DEPARTMENT OF HIGHWAYS - ONTARIO			
MATERIALS & TESTING DIVISION - FOUNDATION SECTION			
DEVELOPMENT ROAD 724			
STA. 39 + 00 TO STA. 42 + 00			
KING'S HIGHWAY NO. _____		DIST. NO. 2 _____	
CO. MIDDLESEX			
TWP. W. WILLIAMS & ADELAIDE LOT _____		CON. _____	
BORE HOLE LOCATIONS & SOIL STRATA			
SUBWD. A B	CHECKED <i>19</i>	W.P. NO. _____	M.S.T. DRAWING NO. _____
DRAWN S.O.	CHECKED _____	JOB NO. 67 - F - 95-1	67 - F - 95 B.
DATE 18 JUL 1968	SITE NO. _____	BRIDGE DRAWING NO. _____	
APPROVED <i>A. B. Thomas</i>	CONT. NO. _____

SUPPLEMENTARY REPORT ON THE SOILS  
INVESTIGATION AT THE FAILURE AREA

On Development Road #724  
Sta. 39+00 to Sta. 42+00  
County of Middlesex  
W.J. 67-P-95-1 -- Dist. #2 (London)

Repairs to Development Road #724  
W.J. 67-F-25 -- District #2 (London)

DRAWING 67-F-95 D

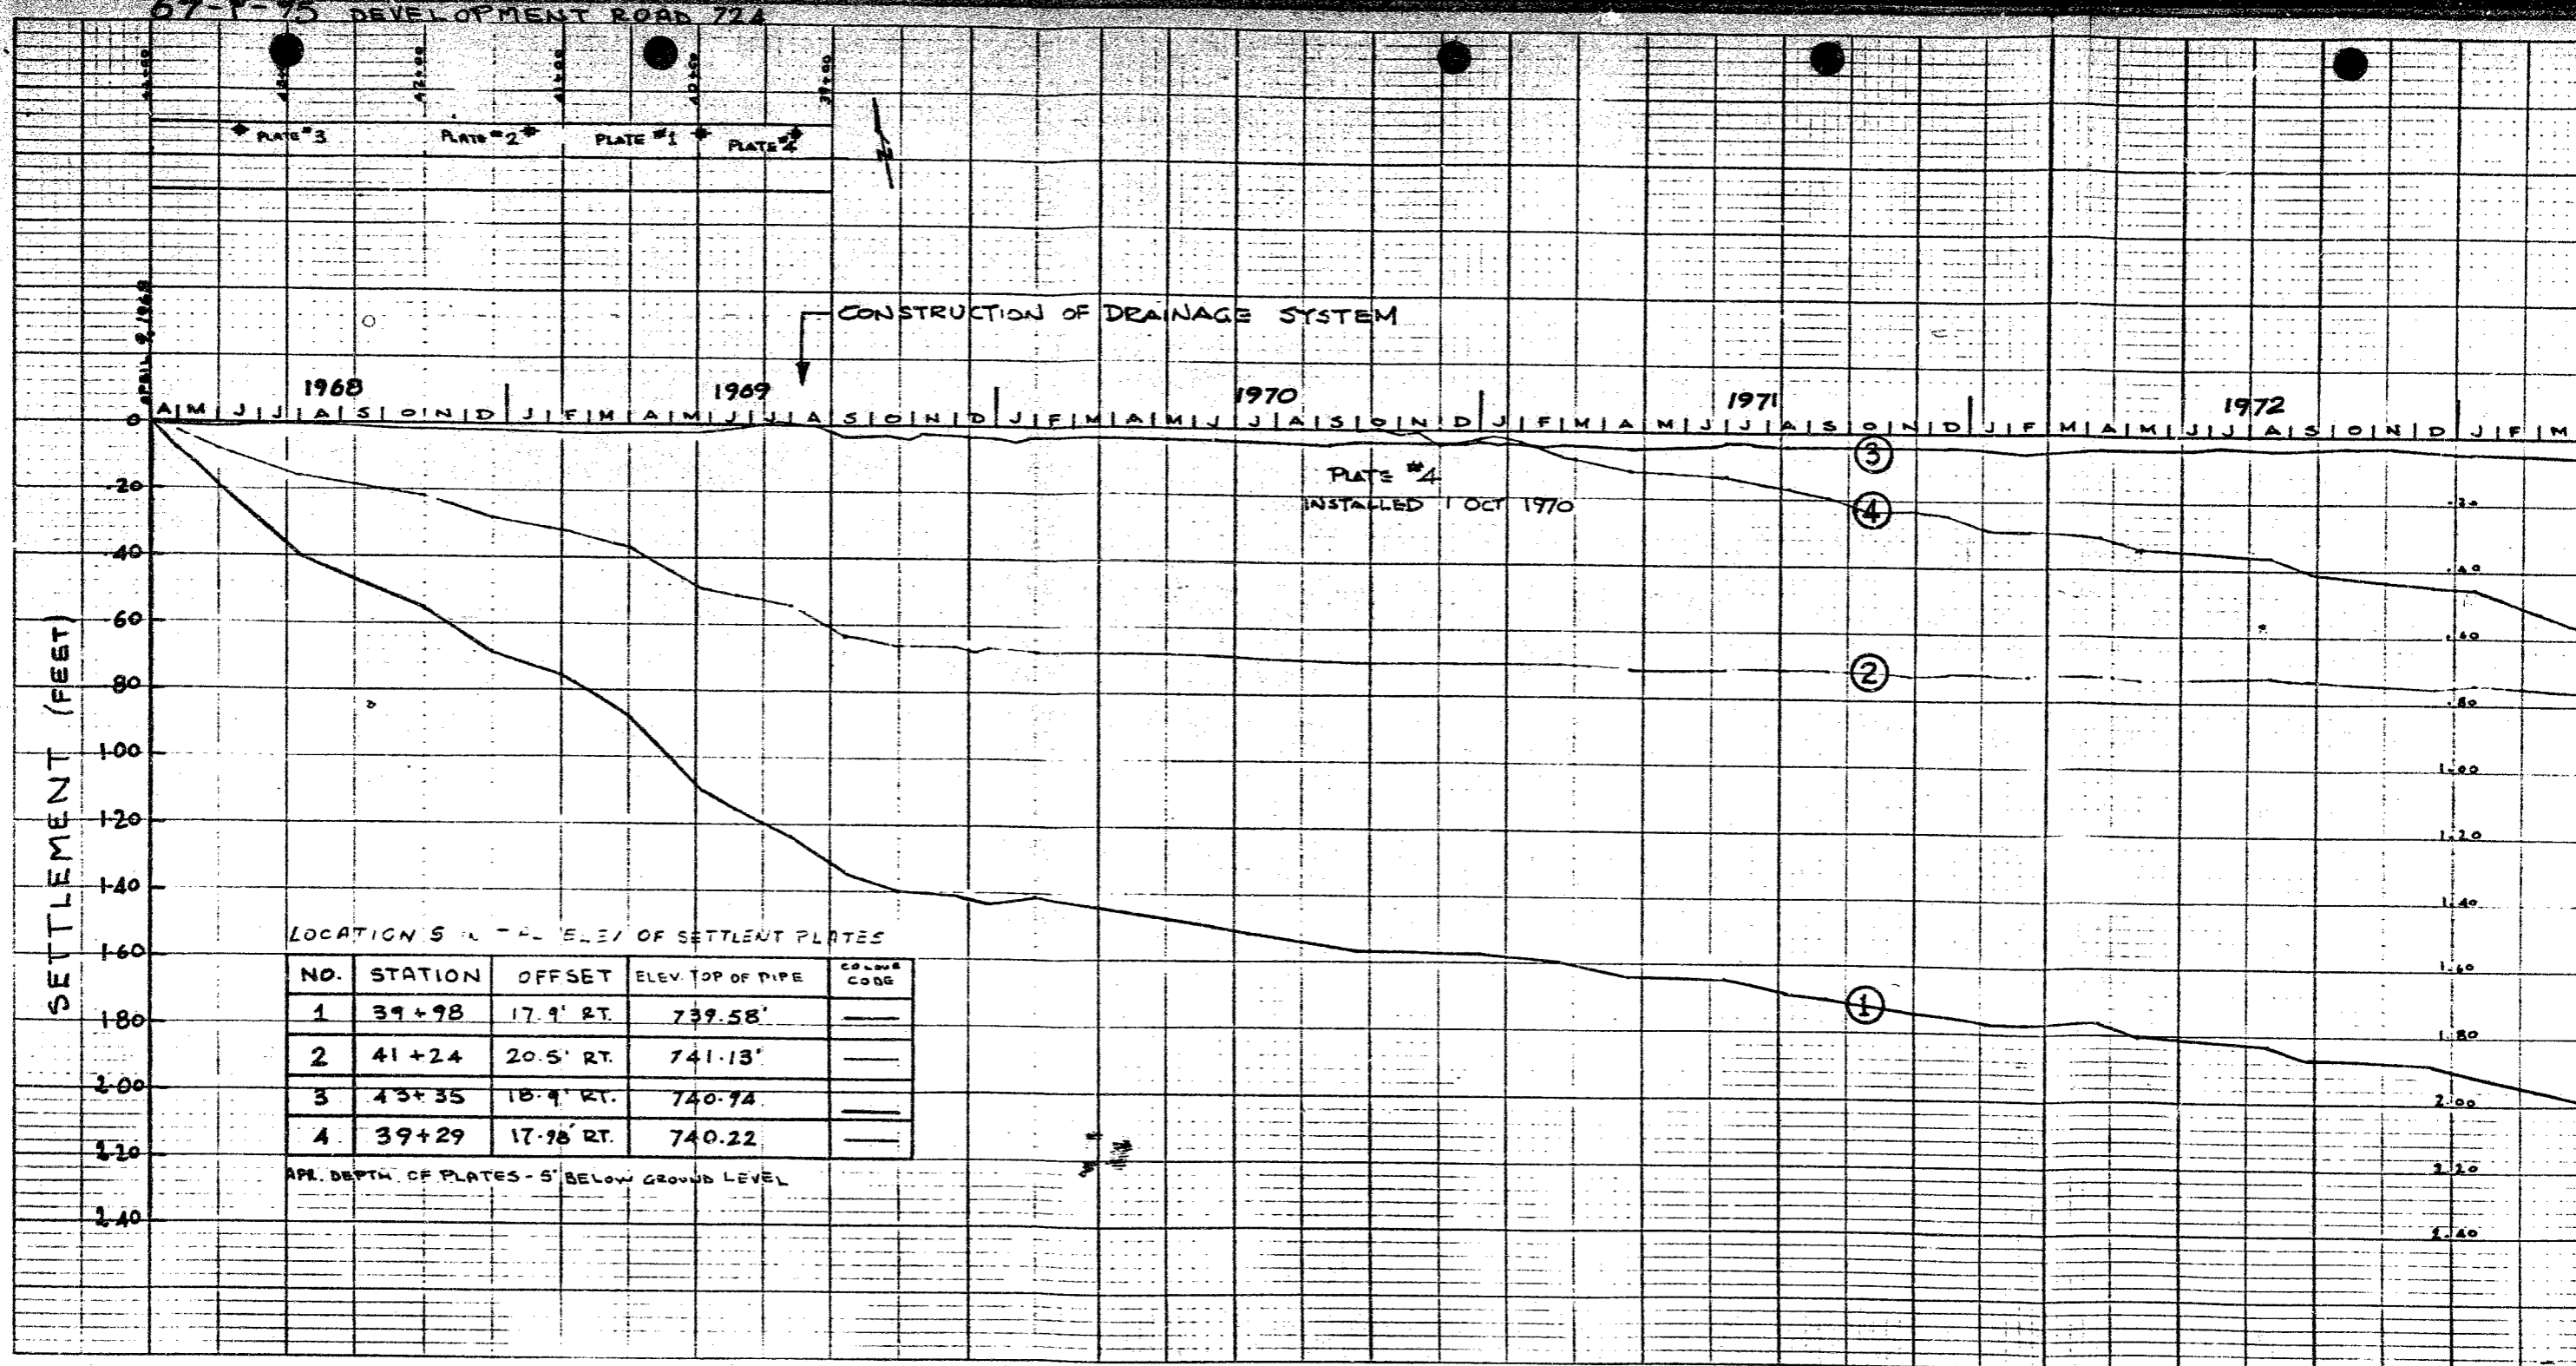
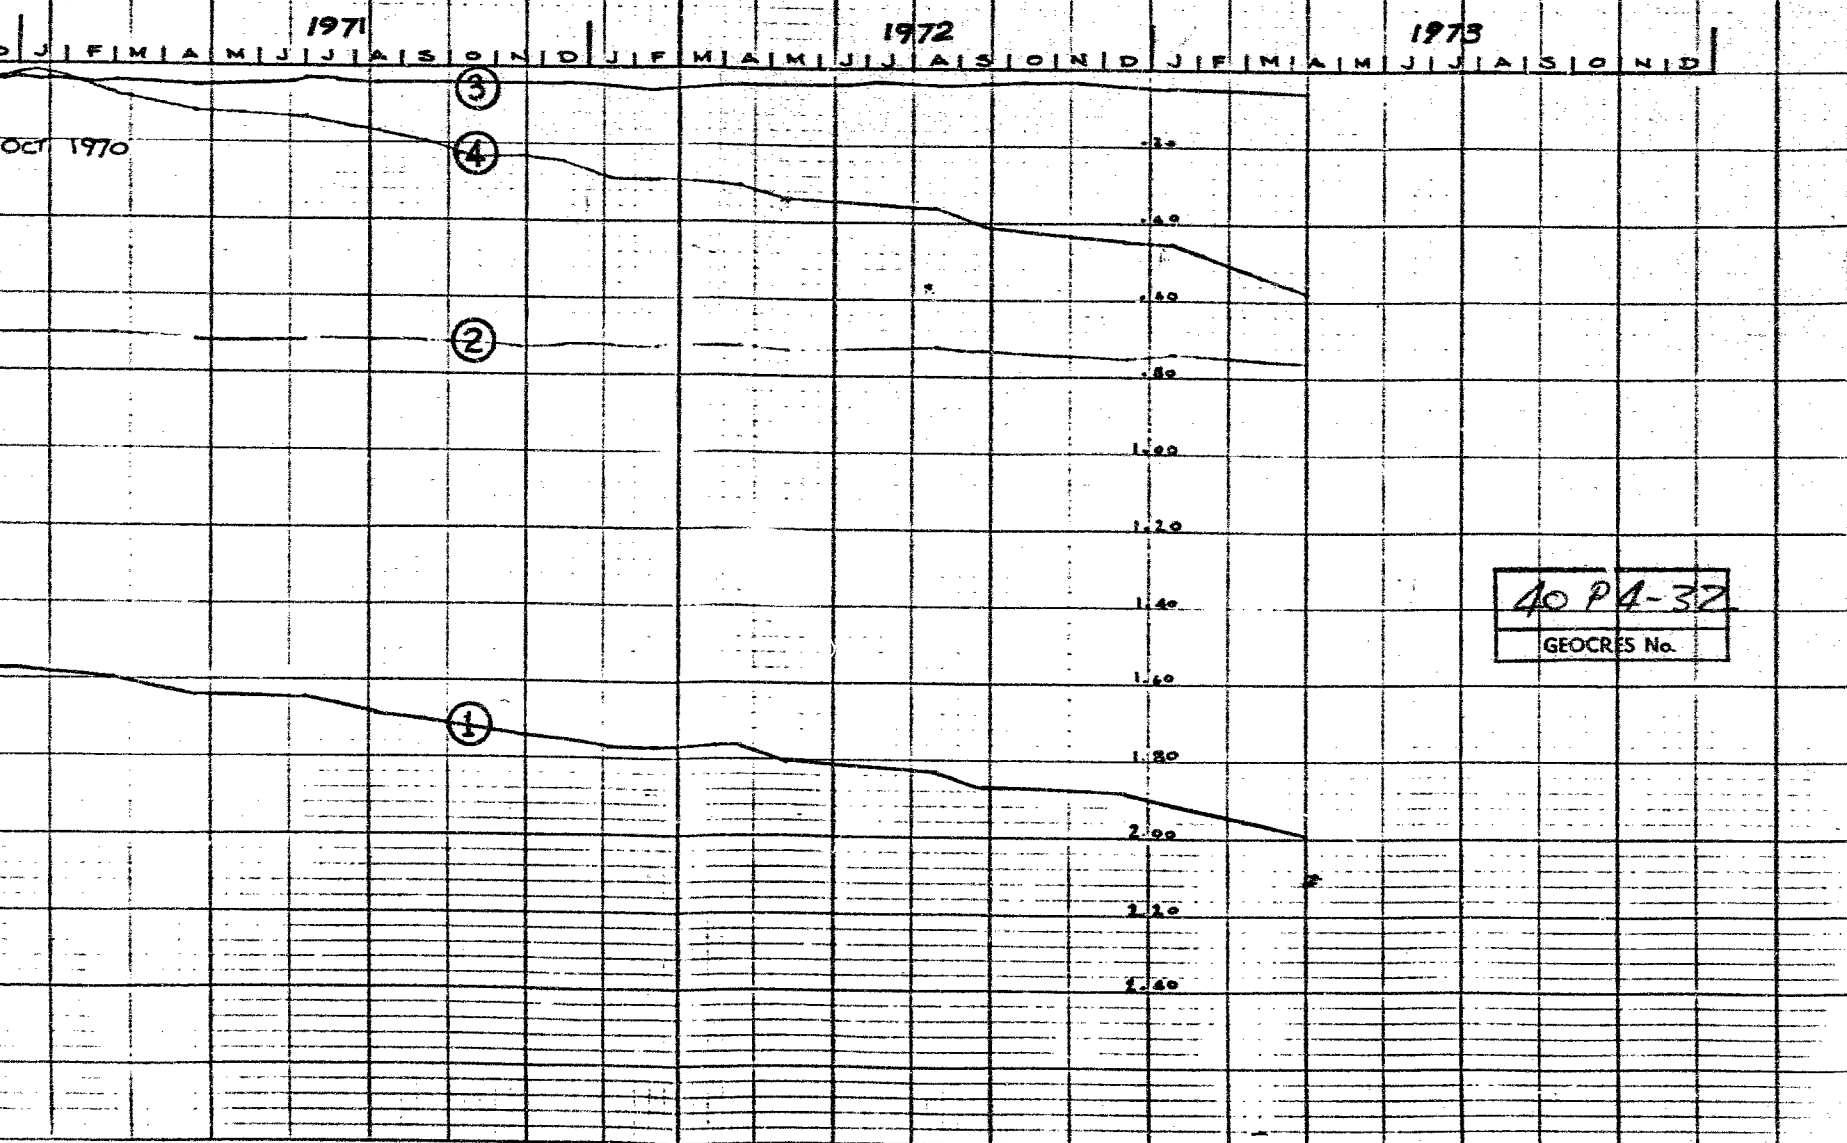
A study of the settlement records (see attached Drawing 67-F-95D) shows that the immediate result of the new drainage system was a significant decrease in the rate of settlement; i.e., at Sta. 40+00 the rate decreased from 1/4 inch per week to 1/25 inch per week. West of Sta. 41+25 the rate decreased from 1/10 inch per week to zero. In the fall of 1970 the new pavement cracked over an area some 200 ft. long centred about Sta. 39+30. A new settlement plate was installed at Sta. 39+25 in October 1970 and subsequent records show a steady rate of settlement of about 1/20 inch per week. It is now evident that settlement is likely to continue at more or less the same rate along the entire area between Stas. 38+00 and 41+00 for many years to come.
